**Re: Release Characterization Report and
Proposed Remediation Work Plan - Addendum
Yates State #2 Tank Battery
NMOCD Case No. 1R-4587
Lea County, New Mexico**

DOCUMENT TITLE
RELEASE CHARACTERIZATION REPORT AND
PROPOSED REMEDIATION WORK PLAN - ADDENDUM

FIGURE TITLE
**PROPOSED TEMPORARY
MONITORING WELLS**

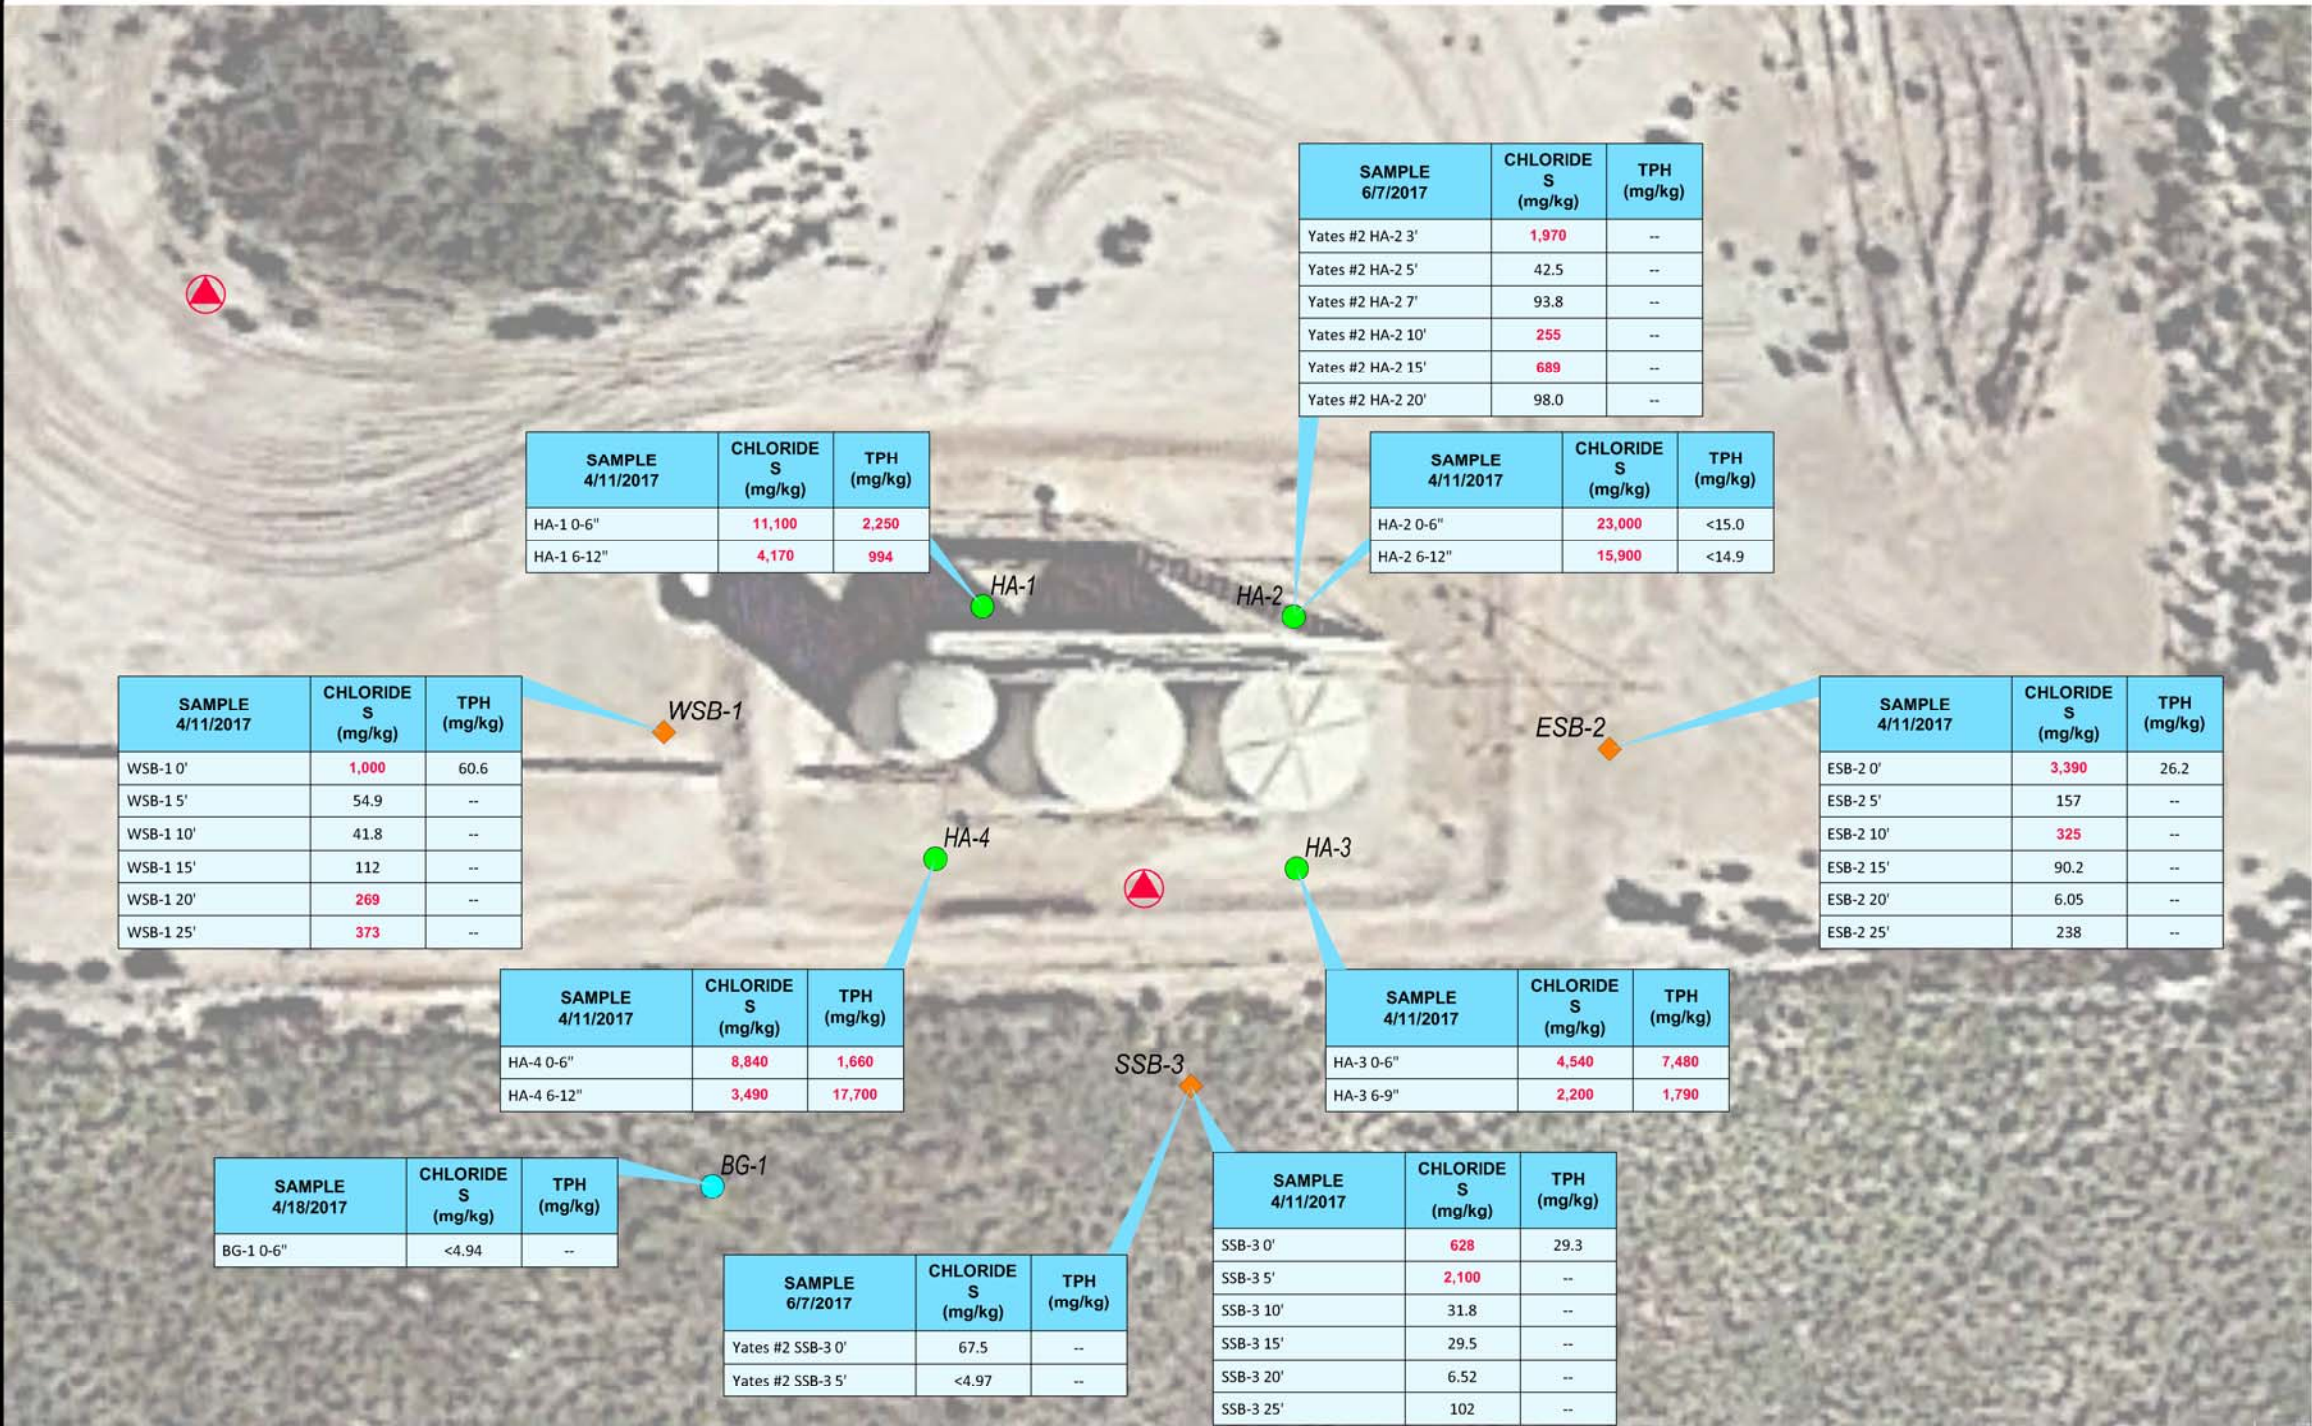
NMOCD approves of the proposed location of the 2 temporary groundwater monitoring wells for 1RP-4587. Please see email for conditions related to the proposed remediation plan.

Comment No. 6: Please demarcate the dimensions of the release area on the scaled map.

Comment No. 7: Due to the depth to groundwater, a temporary groundwater monitoring well may be required to determine potential impact of release.

Response: The figures provided are scaled drawings, but ECC will denote the dimensions of the secondary containment wall (i.e., the release area). The dimensions of the secondary containment of the tank battery are approximately 120 feet west-to-east and 45 feet north-to-south.

1. Two (2) temporary groundwater monitoring wells will be installed to assess brine impacts to groundwater at locations expected to be hydraulically upgradient and downgradient relative to the subject tank battery. RAM's proposed locations of these temporary monitoring wells are shown on attached **Figure 1**. At each of these locations a boring will be drilled using air-rotary drilling methods to a depth of approximately 30 to 35 feet below grade. A temporary PVC screen and casing will be lowered into the open borehole. Prior to sample collection the wells will be developed by removing several bailers of water to ensure representative groundwater samples are being collected. A groundwater sample will be collected from each monitoring well and submitted to the laboratory for analysis. Although not specifically discussed, ECC proposes that the groundwater samples be submitted to the laboratory for chloride, sodium and total dissolved solids analyses. When the groundwater samples have been collected, the temporary screens and casings will be removed and the boreholes will be fully pressure grouted from bottom to top.

2. ECC will provide the NMOCD a figure showing the locations of the two proposed temporary groundwater monitoring wells prior to them being drilled. This is accomplished with this submittal (see **Figure 1**).
